**RE: Presbyterian Hospital Expansion
1100 Central SE et al.
Conceptual Grading and Drainage Plan
Engineer's Stamp Date: 10/3/19
Hydrology File: K15D005**

Based on the submittal received on 10/3/19, the Grading and Drainage Plan cannot be approved until the following corrections are made:

DRAINAGE PLAN

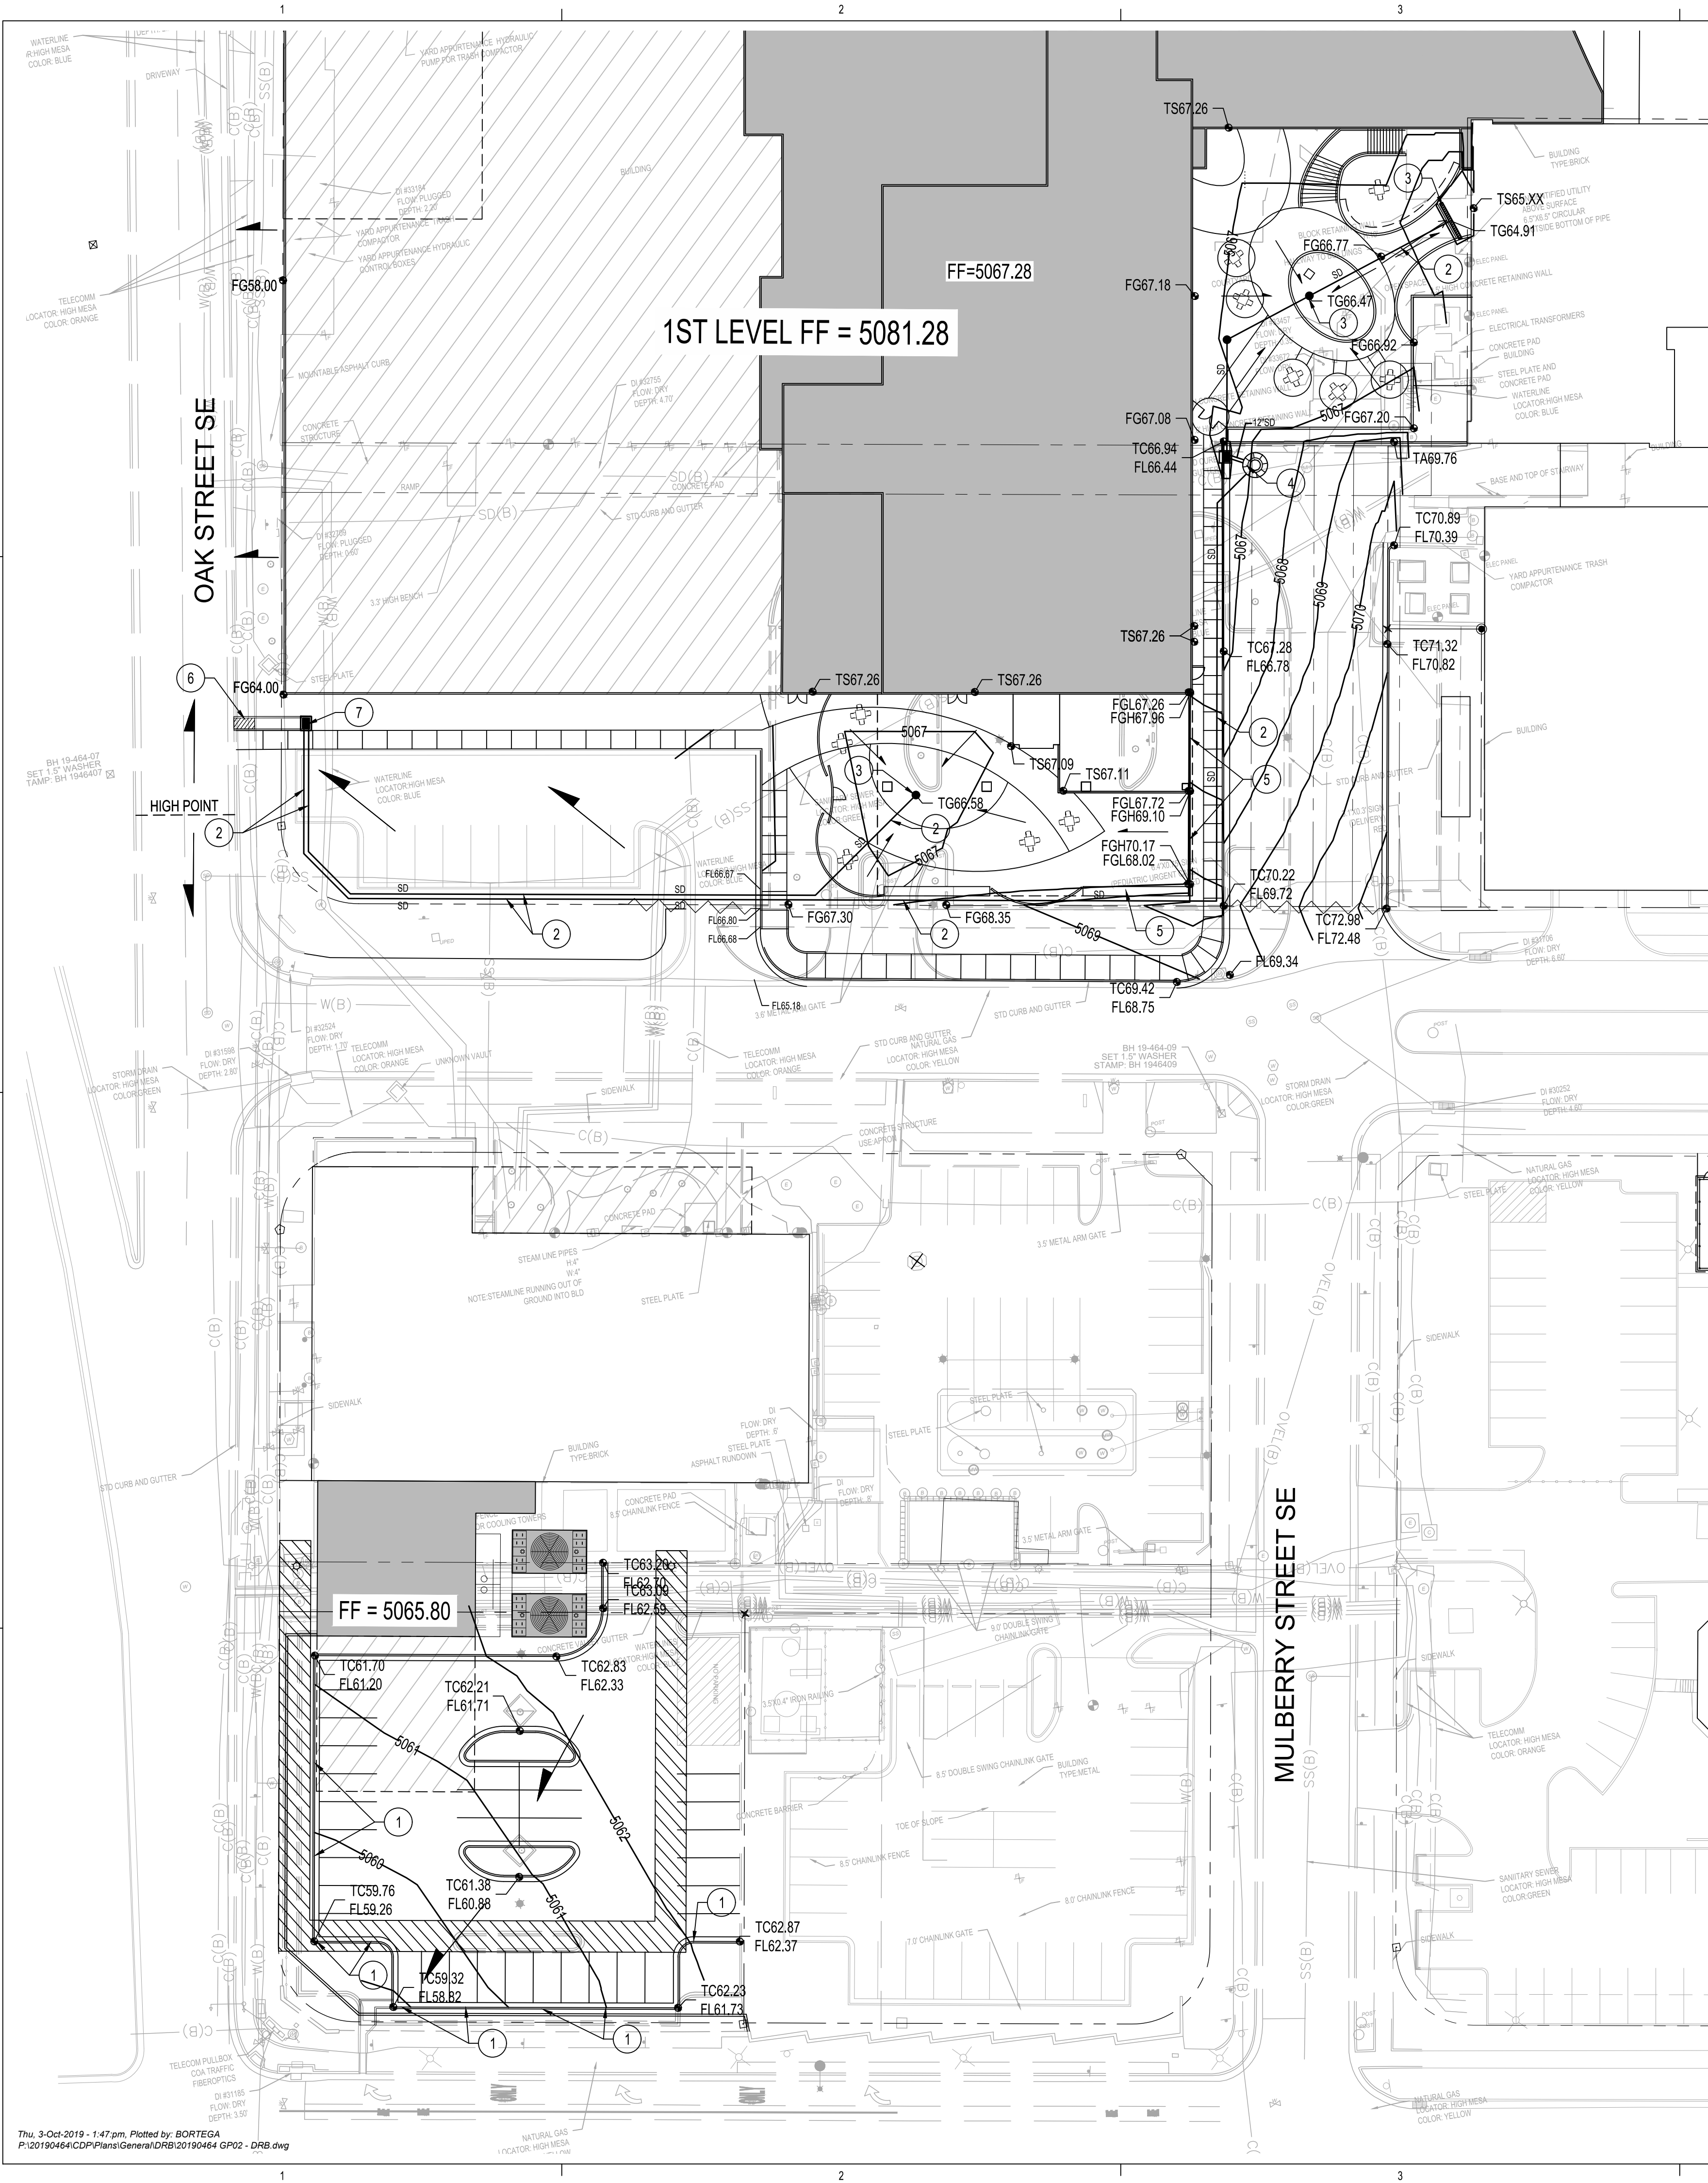
10. Payment in Lieu (Amount = TBD) of onsite management of the stormwater quality volume (SWQV) must be made. Provide SWQV calculations.
11. Provide hydraulic calculations for the proposed storm drain system (Patient Tower area), calculated along the Energy Grade Line; include both the HGL and EGLs in the table.

12. Provide the design for the lift station. Include pump curves, a section showing elevations of pump-on, pump-off, max WSE, etc..., contributing area hydrology. Where is the emergency overland path, or the extents of the ponding if the pump fails?

13. Flow depth (and EGL) on Silver, in front of the garage entrance, needs to be calculated. Demonstrate that the EGL is less than the proposed waterblock height. Otherwise a standard 0.87' waterblock is required.

CONCEPTUAL
GRADING AND
DRAINAGE PLAN
AREA A

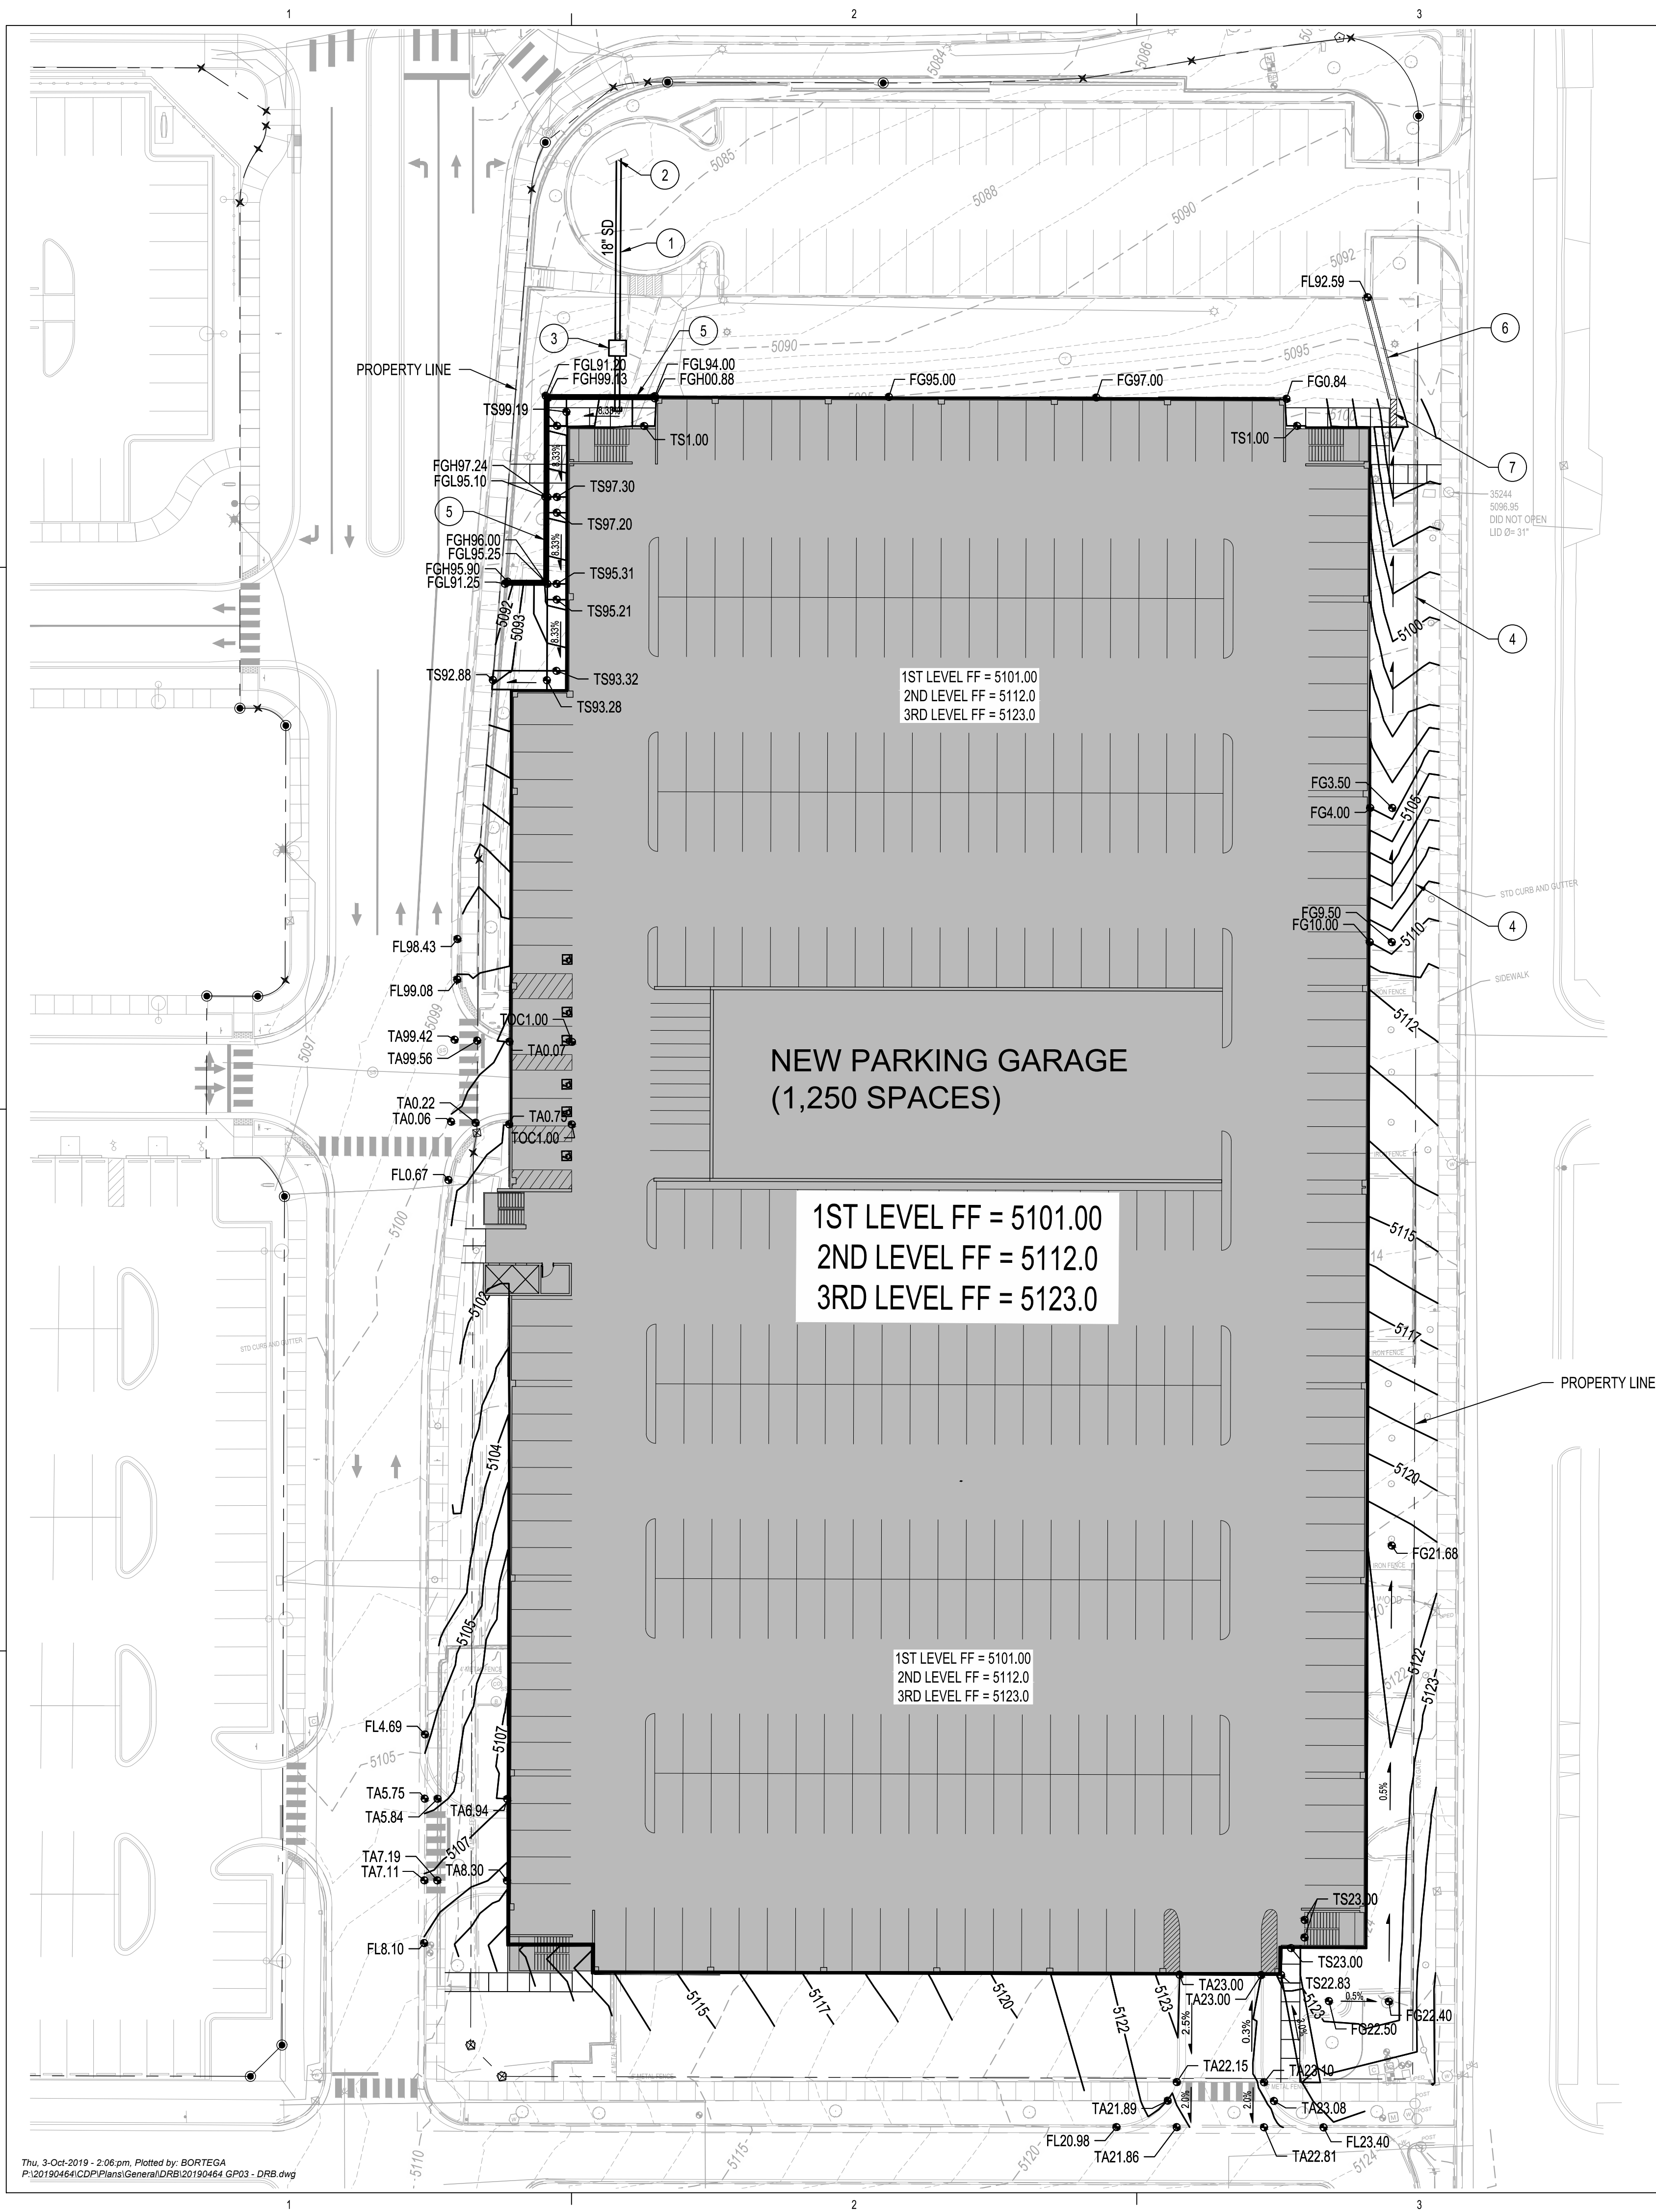
1. The grading plan needs to cover the full extent of the work. The north edge of the Patient Tower area is clipped. It may be easier just to make the Patient Tower area a separate viewport from the Energy Plant.

2. Provide hydraulic calculations for the channel and sidewalk culvert discharging to Oak. The sidewalk culvert(s) should be included on the Infrastructure List (or build by SO-19, if no other infrastructure is identified by the DRB). Also, the work here will require a NMDOT permit.

3. Provide hydraulic calculations for the channel and sidewalk culvert discharging to Lead. A second sidewalk culvert is likely required here to pass the Q_{100} of 6.1cfs and should be included on the Infrastructure List (or build by SO-19, if no other infrastructure is identified by the DRB).

4. Provide existing contours, showing how the proposed grading will tie-in at property line. This is provided on the parking garage viewport, but not the other two areas.

5. Provide sections through all external boundaries with proposed walls showing the proposed walls and their footers; identify retaining vs. garden vs. stem wall, show property/ROW lines, and existing and proposed grades. In accordance with DPM Ch.22, section 5 part B, grading and wall construction near the property line may not endanger adjacent property or constrain its use.

- a. Any private encroachment into the public ROW will require a revocable permit.
 - b. Any private encroachment into a public easement will require an encroachment agreement.
 - c. Any private encroachment into neighboring private property will require written and signed permission from both property owners.
6. What is the odd U-shaped hatched area on the Energy Plant viewport? Is it relevant to the grading and drainage or can it be removed?
